**From:** Russell Lumb  
**Sent:** 06 March 2019 11:23  
**To:** Jill Bastow  
**Subject:** Re: NYM/2019/0040/FL Susannah Hill Cottage, Browside

SUSANNAH HILL COTTAGE, BROWSIDE, RAVENSCAR

ALTERATIONS AND EXTENSIONS FOR DAVID BOWES  
JANUARY 2019  
PROPOSED FIRST FLOOR PLAN 1:100 @ A3

RL 18.01.06A

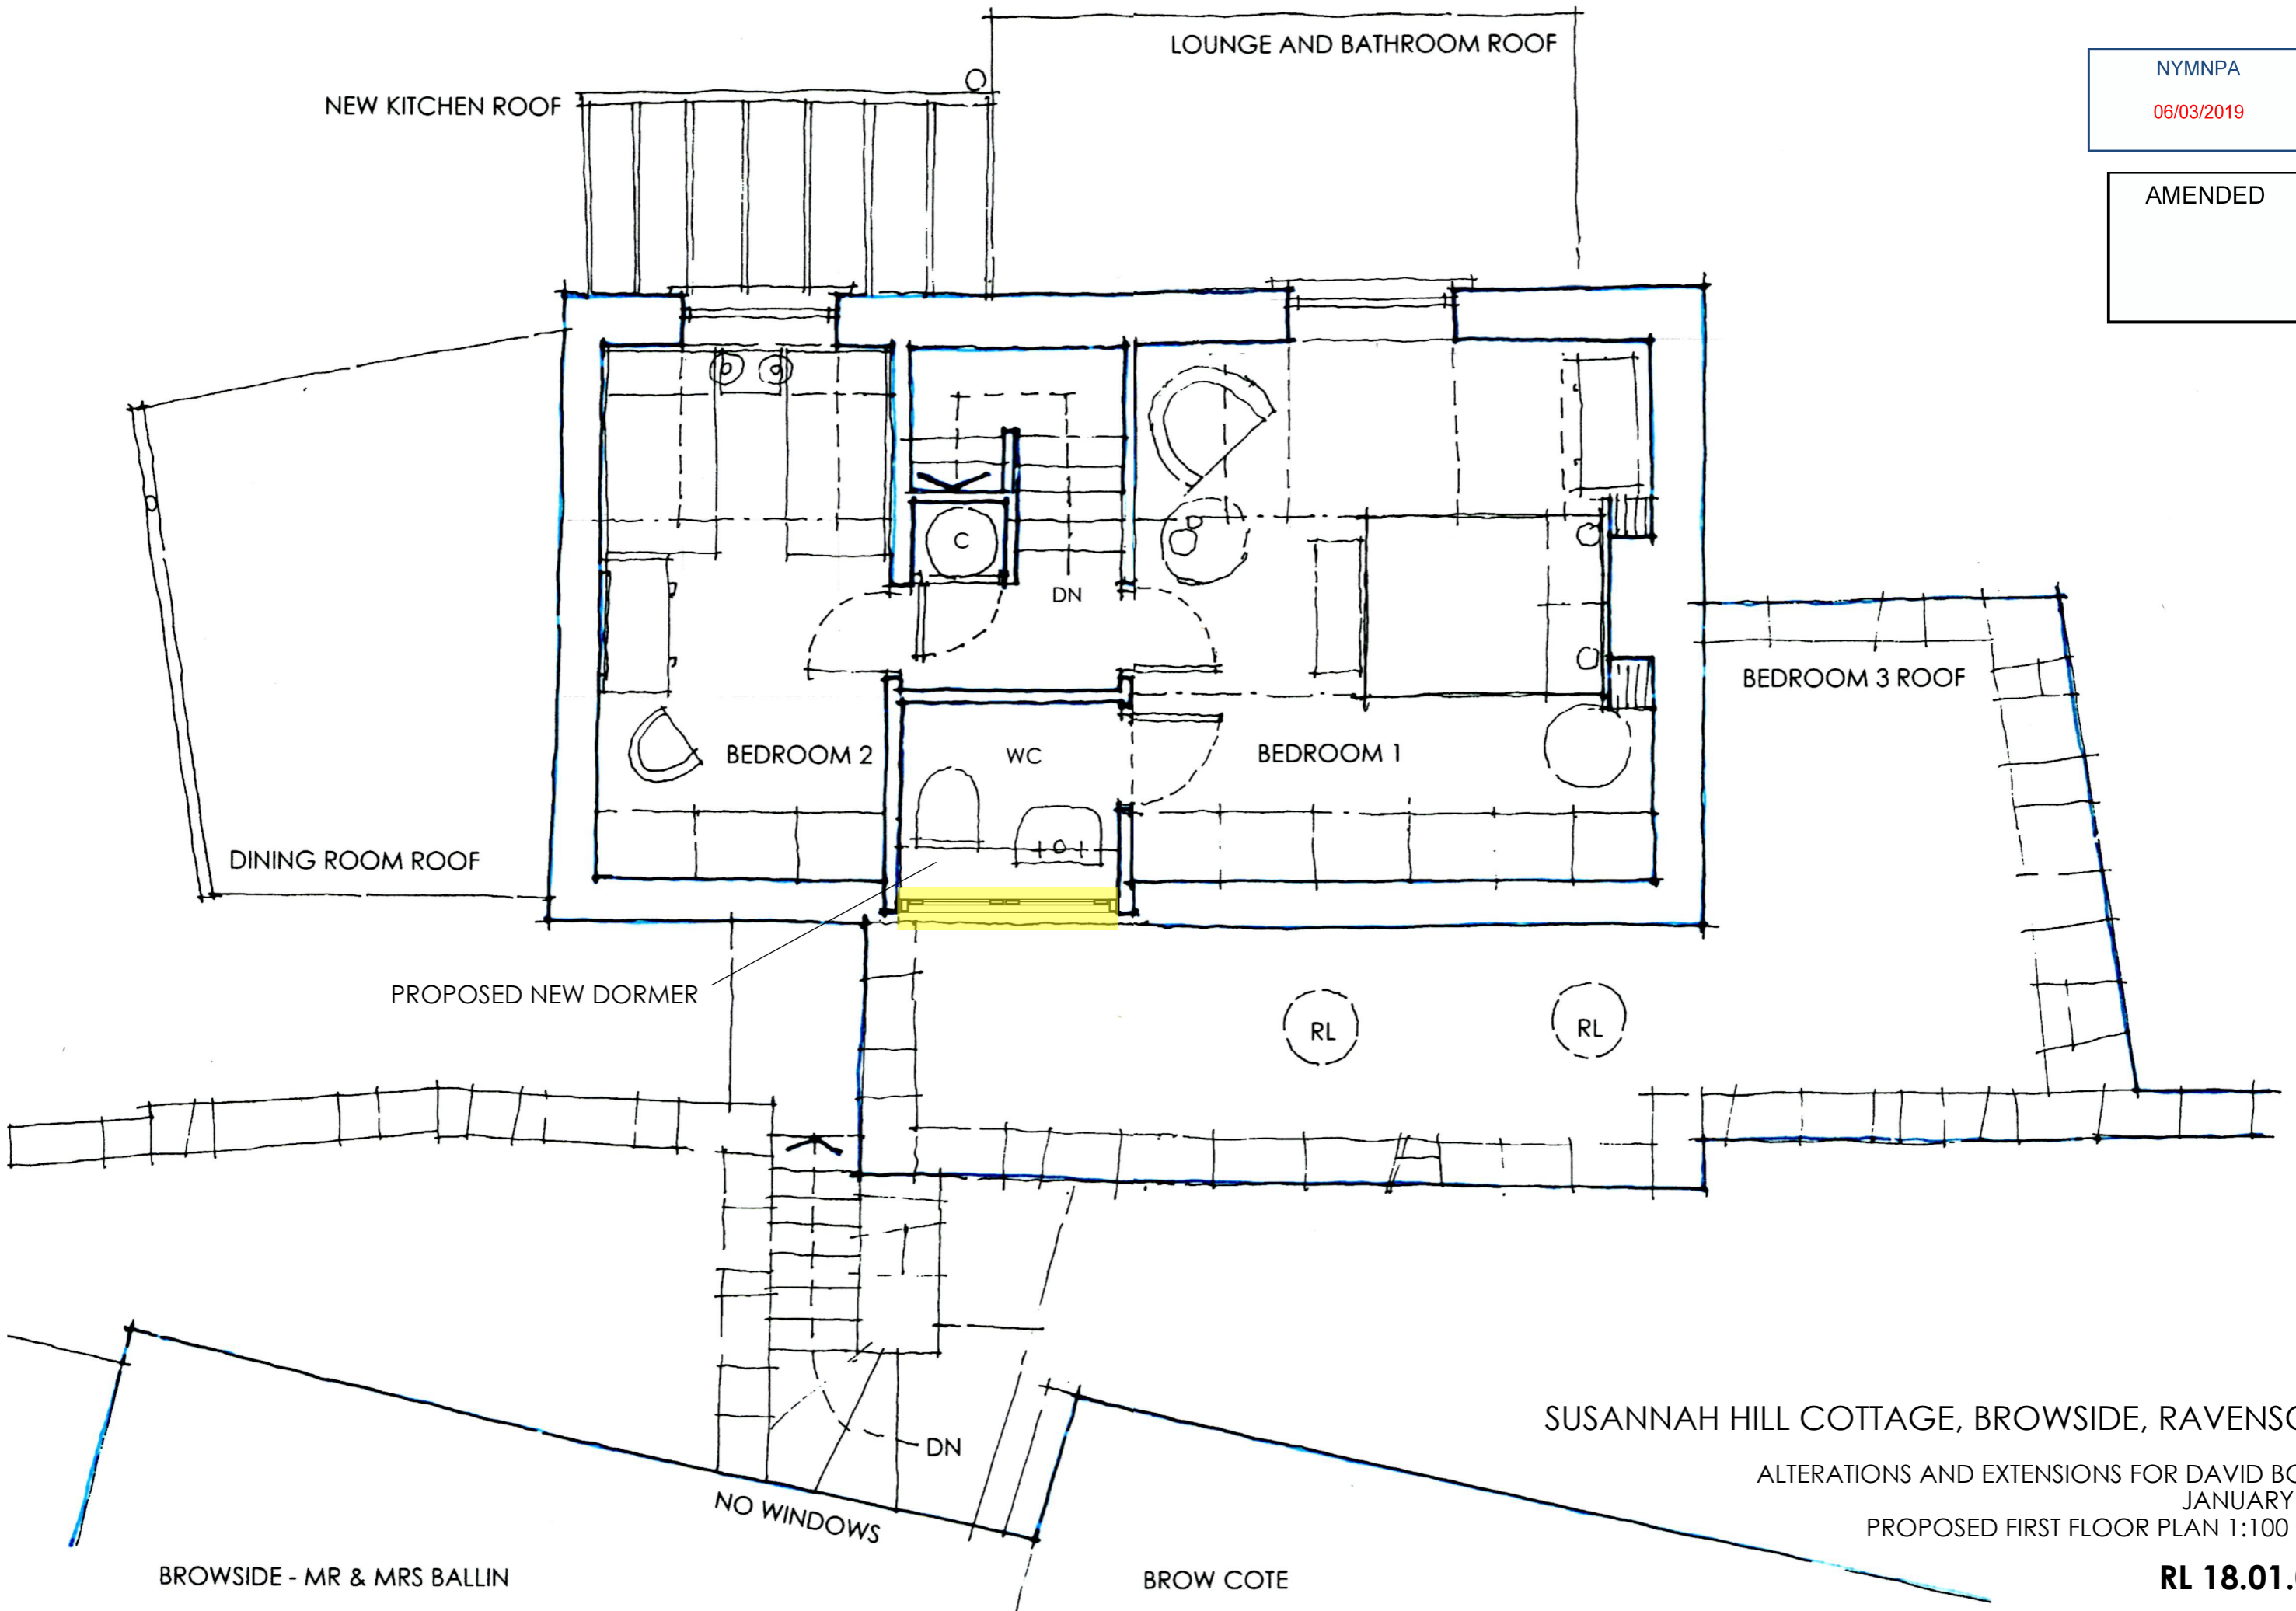
Apologies for the discrepancy between plan and elevation for the proposed new dormer, and please find attached revised First Floor plan 18.01.06A indicating a full-width window to the S.W. elevation.
